PROPERTY ADDRESS: 1915 Lyndhurst Avenue

SUMMARY OF REQUEST: Rear and Second Story Addition

Charlotte Historic District Commission - Case 2014-042

2
A-4 Right Side Elevation
1/8" is equal to 1'-0"

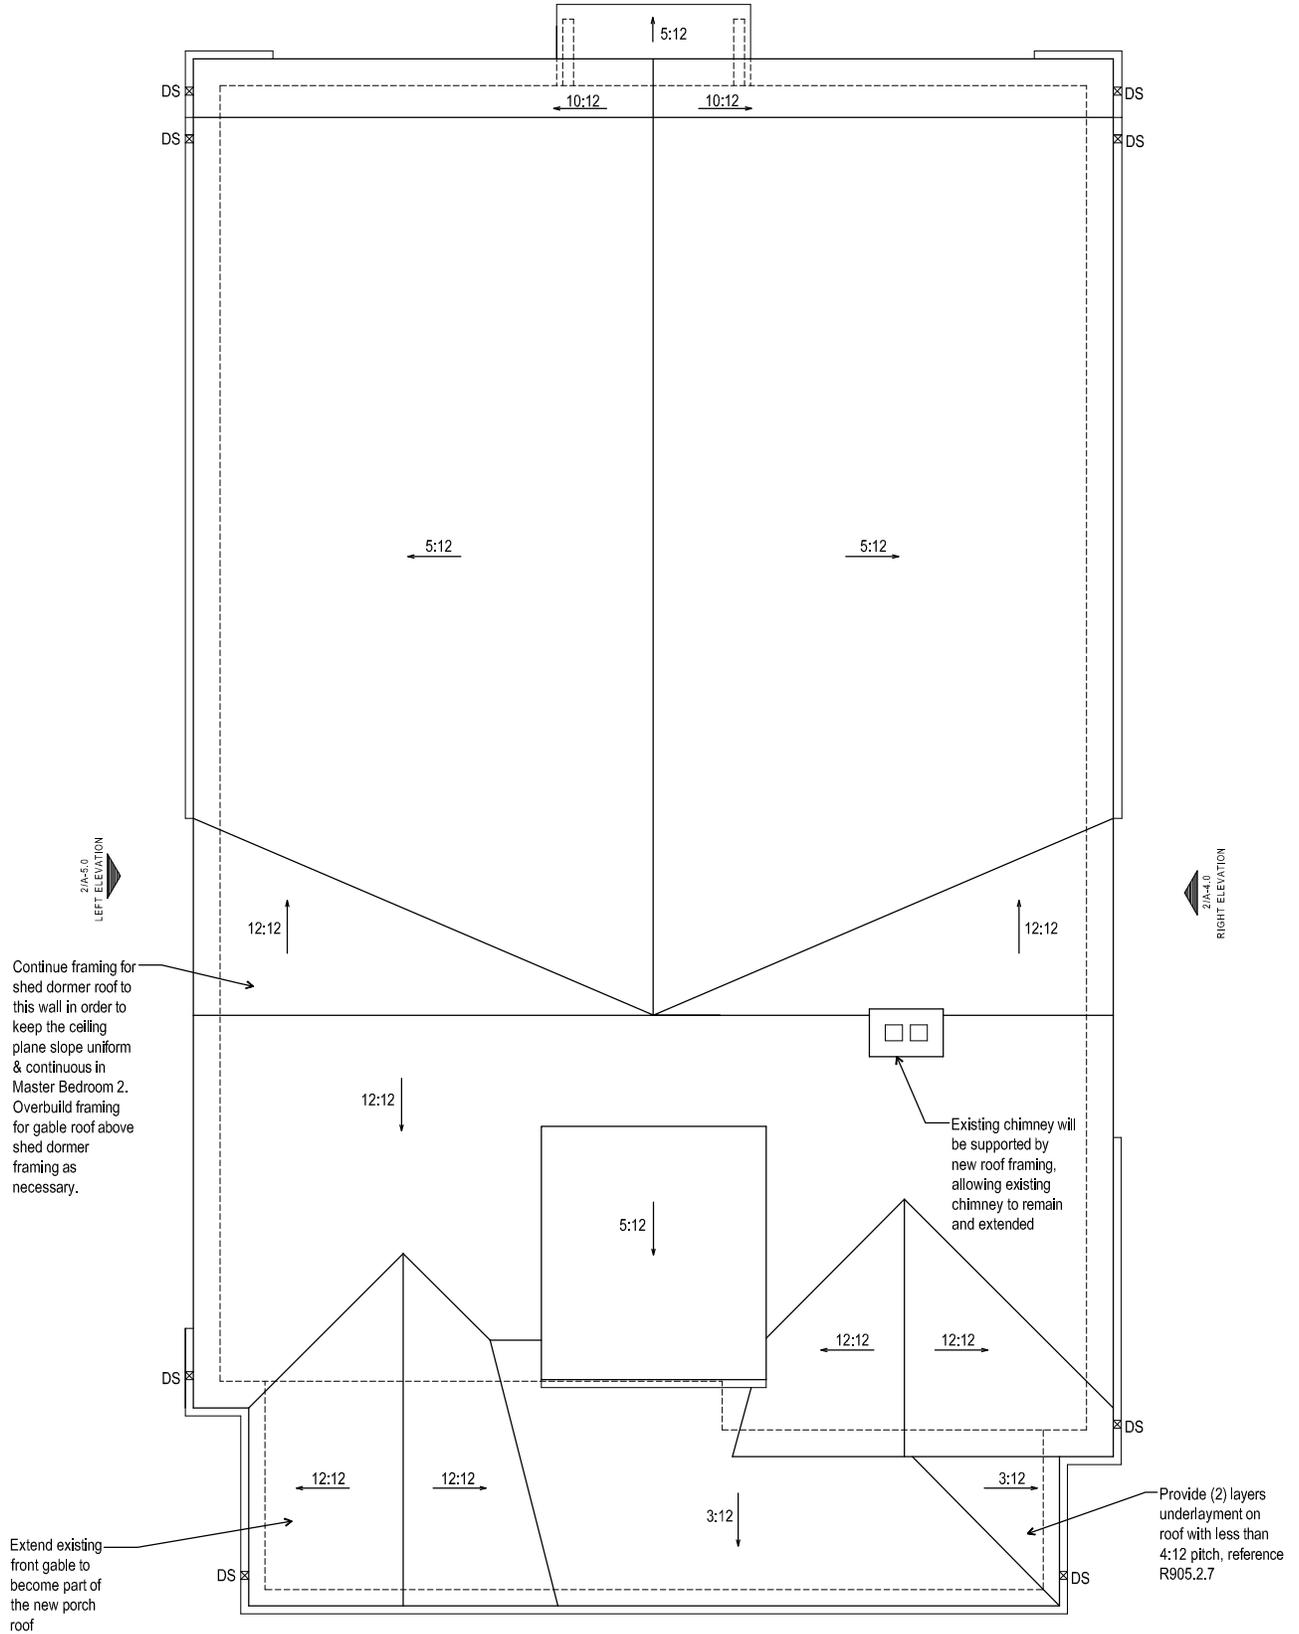
During construction a stability issue was raised with the right side chimney. In order to save the chimney the applicant is seeking to amend the COA by shifting the right side gable forward to partially enclose the chimney. As a result, there are changes in the window arrangement on the second floor but will be the same type as previously approved.

Continue framing for shed dormer roof to this wall in order to keep the ceiling plane slope uniform & continuous in Master Bedroom 2. Overbuild framing for gable roof above shed dormer framing as necessary.

Existing chimney will be supported by new roof framing, allowing existing chimney to remain and extended

Proposed Front Elevation

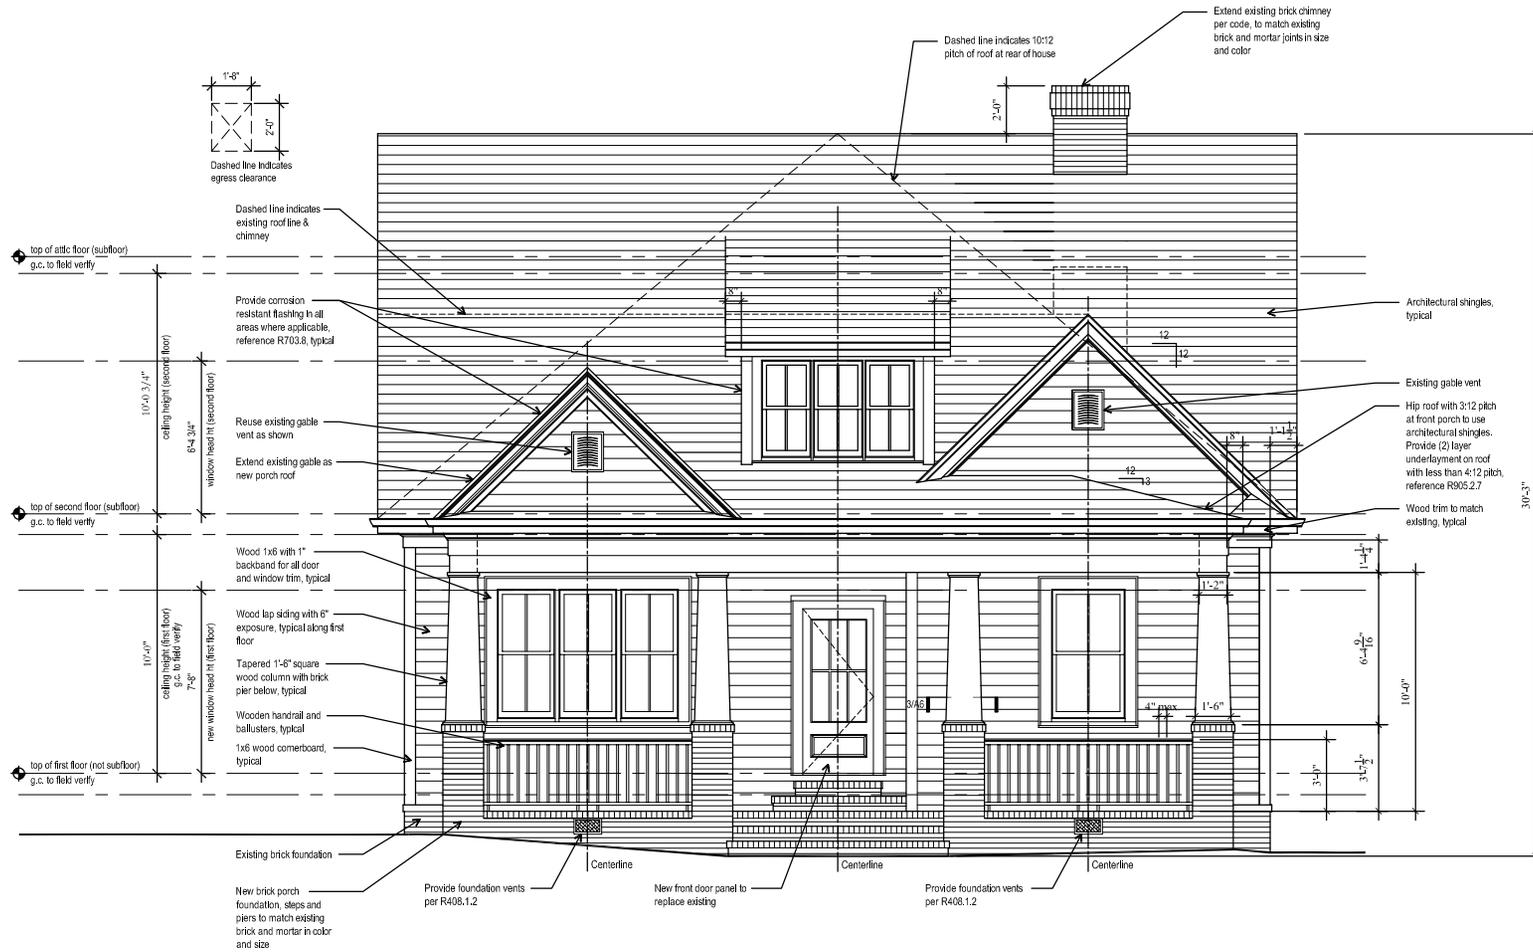
Extend existing front gable to become part of the new porch roof

Provide (2) layers underlayment on roof with less than 4:12 pitch, reference R905.2.7
